SERVICE BULLETIN

SB1214

| COACH/BUS MODEL | : T2140, T2145, C2045 |
| SUBJECT | : New charge air cooler |

Charge air cooler
Refrigeración de aire de admisión

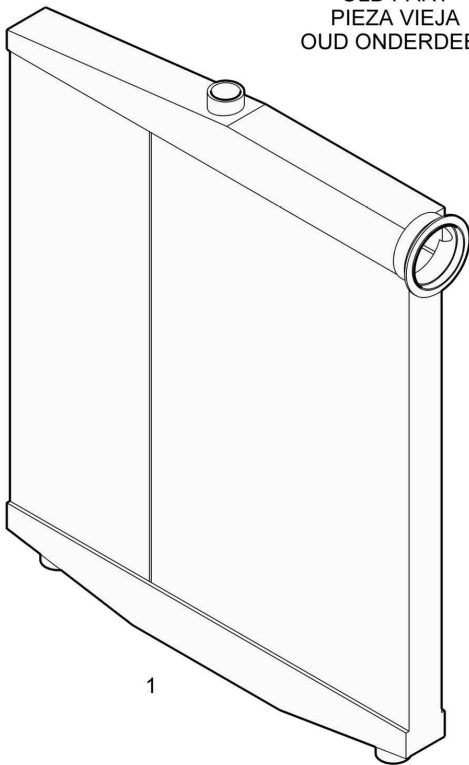
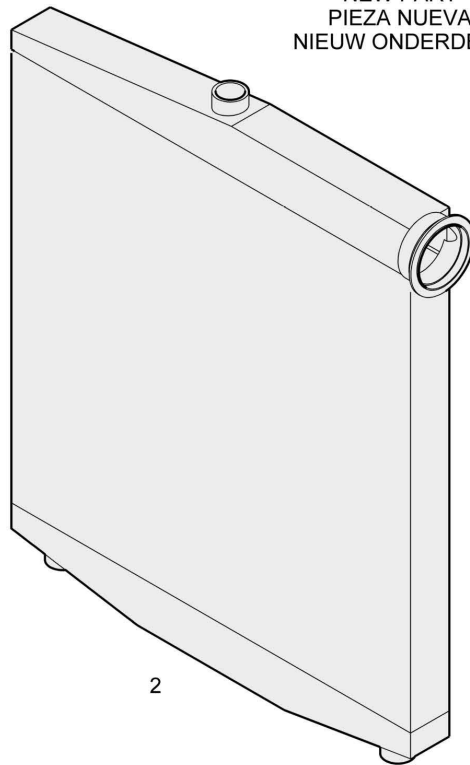
3. To ensure system performance and address structural integrity issues, charge air cooler #VH 10838305 has been superseded by charge air cooler #VH 11003917, which is designed for off-highway applications and harsh operating conditions.

The core of the new cooler no longer has seamless tubes with turbulators inside them, and fins to cool the charge air, but fusion-welded plate-and-bar tubes with turbulators inside, and fins on the outside.

This type of cooler manufacturing provides for improved rigidity and mechanical strength whilst maintaining cooling capacity.

- Old and new parts are interchangeable, but only the new will be offered as service replacements.
- To identify: old parts have two adjacent cores and have the brand name “AKG” embossed on the top and bottom tank. The lower tank is stepped in relation to the core. A label on the core frame provides the VH and manufacturers part number and production data.
- To identify: new parts have a single core and have the brand name “RAAL” embossed on the top and bottom tank. The lower tank is flush in relation to the core. A label on the core frame provides the VH and manufacturers part number and production data.
- Parts may be purchased from your nearest ABC Customer Care & Parts Source service center.
- Parts/Waste disposal: discard old parts and products according to applicable environmental regulations.

| Pos. | Q. | Ref.N° | Description | Denominación | Spec. |
|------|----|----------|-------------------------------|-----------------------------------|-------|
| | | | 10838305 replaced by 11003917 | 10838305 reemplazado a 11003917 | |
